# Norwich to Tilbury

**Document: 8.3.27 Draft Statement of Common Ground - Blackwater  
Aggregates (Bradwell Quarry) - Clean Version**

**Planning Inspectorate Reference: EN020027**

Figure 1 Interface between Bradwell Quarry and the Project Alignment

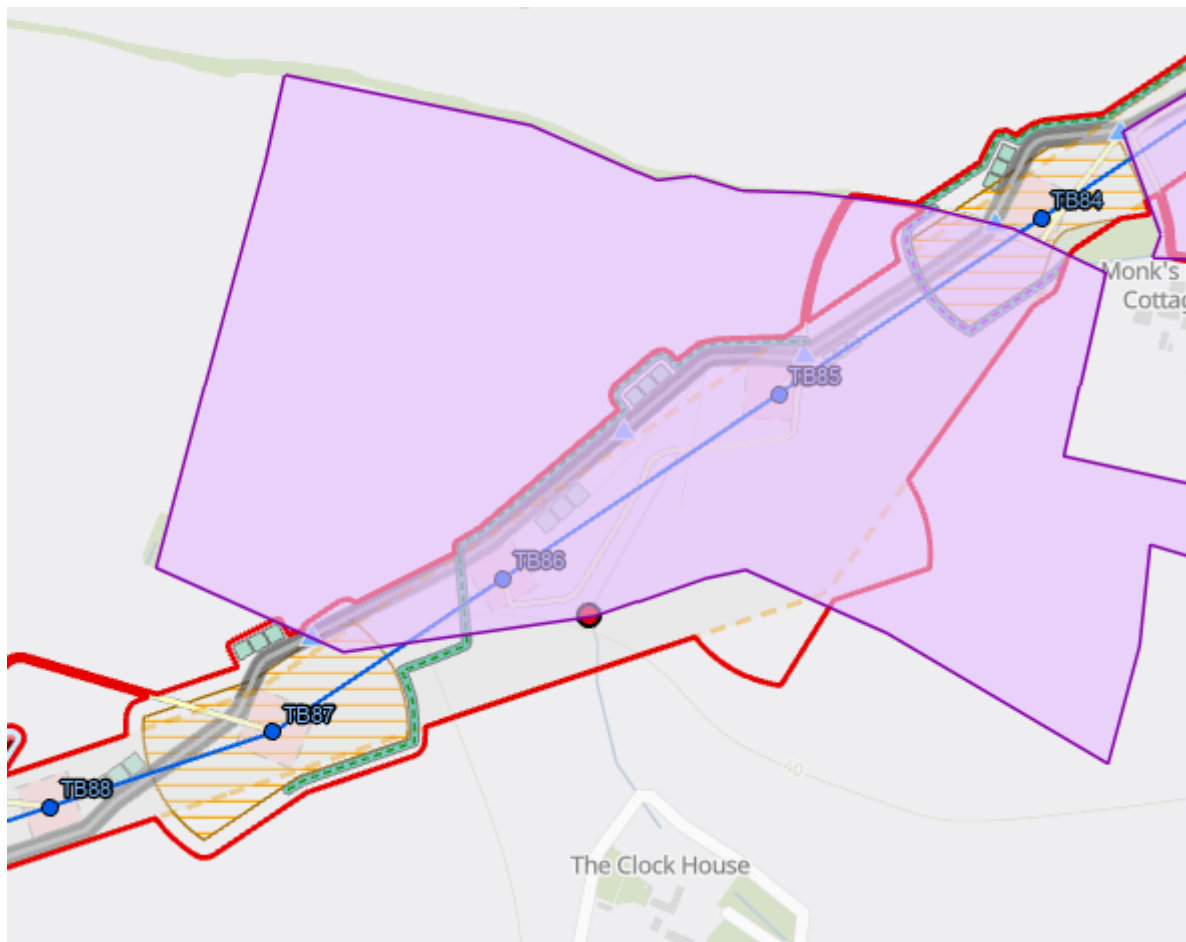
ID	Issue	National Grid Position	Stakeholder Position	Status	Relevant documentation
7.1	Route Scenarios	<p>The Applicant has identified the interface between the Norwich to Tilbury project and the Bradwell Quarry Monks Farm development. To accommodate ongoing discussions and potential changes to the planning status of the Monk's Farm site, the Applicant has developed a design scenario that provides flexibility for future adjustments. This scenario is summarised in the Design Development Report (5.15) and in Chapter 4 of the Environmental Statement (6.4).</p> <p>30/04/26- The two blue lines shown represent alternative route options. The Applicant has committed to the alternative</p>	<p>Blackwater Aggregates submitted the area 8 (area A47 Council ref.) for incorporation into the Mineral Local Plan. Consultation closed in July 2024, and BA await the outcome of the submission.</p> <p>30/04/26 - Please can you explain why there are two blue lines (picture below) shown as a deviation from Monks Farm, heading south to</p>	Ongoing discussion with detailed design to be progressed.	<p>ESS/12/20/BTE planning application with Essex County Council on behalf of Blackwater Aggregates.</p> <p>Essex County Council Mineral Local Plan Review – Assessment of Candidate Sand and Gravel Sites –</p>

7.2	<p>Permanent sterilisation of minerals under electrical infrastructure pillar of support</p>	<p>National Grid notes the potential change in planning status of the Monk's Farm site and the concerns from Blackwater Aggregates in relation to potential mineral sterilisation. As a result, NG identified a design scenario that provides flexibility to respond to ongoing discussions and detailed designs between the two interfaces. A summary of the scenario has been included in the Design</p>	<p>NG to confirm the extent of the protective area around each pylon base if route on existing plans remains unaltered.</p> <p>BA have made clear, through previous consultations, questionnaires and site meetings with NG of the</p>	<p>Ongoing discussion with key points to be confirmed.</p> <p>2 BA have requested the alignment is relocated towards the eastern and southern most</p>

ID	Issue	National Grid Position	Stakeholder Position	Status	Relevant documentation
		<p>Development Report (5.15) and Chapter 4 (Project Description) of the Environmental Statement (6.4) submitted with the DCO application. National Grid welcomes ongoing discussions with Blackwater Aggregates to continue to consider the scenario and detailed design.</p> <p>The Applicant has committed to the alternative option and will now progress with this as the preferred scenario. This has been confirmed to the ExA at Deadline 4 in (8.11) Approach to Scenarios document.</p>	<p>potential significant mineral sterilisation and consequential financial compensation claim arising if the scheme negatively impacts gravel extraction.</p>	<p>point within the route corridor. BA await revised plans from NG showing this re-alignment for further consideration.</p>

ID	Issue	National Grid Position	Stakeholder Position	Status	Relevant documentation
		<p>option and will now progress with this as the preferred scenario. This has been confirmed to the ExA at Deadline 4 in (8.11) Approach to Scenarios document.</p>	<p>a new pylon TB85). We note that the tower base number is marginally different to the numbering shown on the NG interactive Map (Tb85 shown below is TB83 on interactive Map).</p> <p>Is the plan below the correct plan we should be working from, showing the correct revised route?</p> <p>When will the design Review be finalised?</p>		<p>A47 Bradwell, Monk's Farm Design Development Report (5.15) Chapter 4 (Project Description) Environmental Statements (6.4)</p>

Figure 2 Alternative Project Alignment

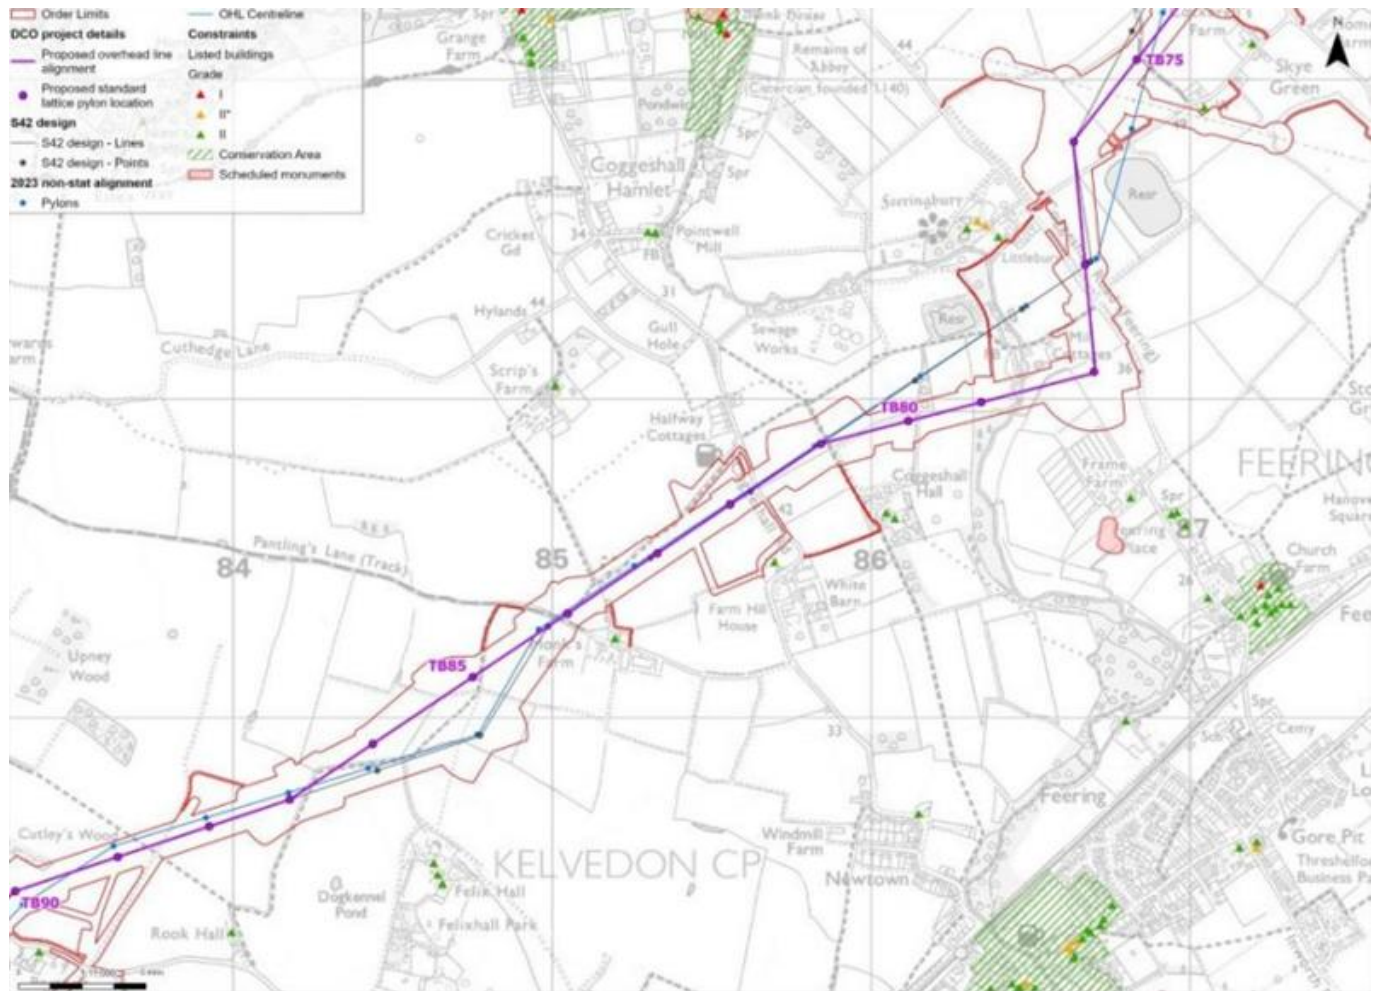
7.3	Alternative Routeing Scenario at Bradwell Quarry	<p>An alternative scenario has been developed that adjusts the overhead line between TB084–TB087. This scenario moves TB086 and TB085 further south, with TB084 positioned closer to the Order Limits, to reduce sterilisation within the quarry. The Applicant considers that siting these pylons at the edge of the development area will lessen mineral sterilisation while maintaining construction access between TB084 and TB085.</p>	<p>BA were informed their suggestion to re-route to an alternative location within the corridor makes little or no marginal cost difference to the scheme. This would make a portion of the mineral reserve financially viable.</p>	<p>Ongoing discussion with key points to be confirmed.</p> <p>BA await revised plans from NG showing this re-alignment for further consideration.</p>

ID	Issue	National Grid Position	Stakeholder Position	Status	Relevant documentation
		<p>The Limits of Deviation have been widened to allow additional flexibility should further extraction opportunities arise.</p> <p>The Applicant has committed to the alternative option and will now progress with this as the preferred scenario. This has been confirmed to the ExA at Deadline 4 in (8.11) Approach to Scenarios document.</p>
